Access Compliance Report Public Rights-of-Way (Pedestrian Signals)

Main Street: IRVINE_BLVD Cross Street: BROWNING_AVE Location: SW

ADA ID: SGRK211006112415 Signal Type: One Push Button-APS Overall Compliance: No Severity Scores: BTN 1: 25 BTN 2: N/A No BTN: N/A

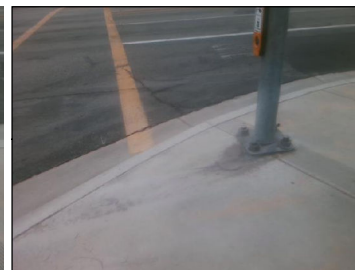
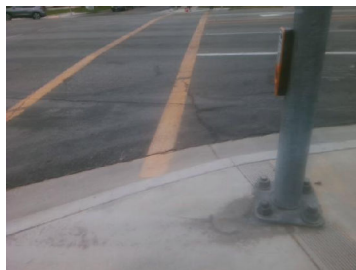
OC Std/PROW: R404.2

Possible Solutions: Remove and Replace Clear Space.
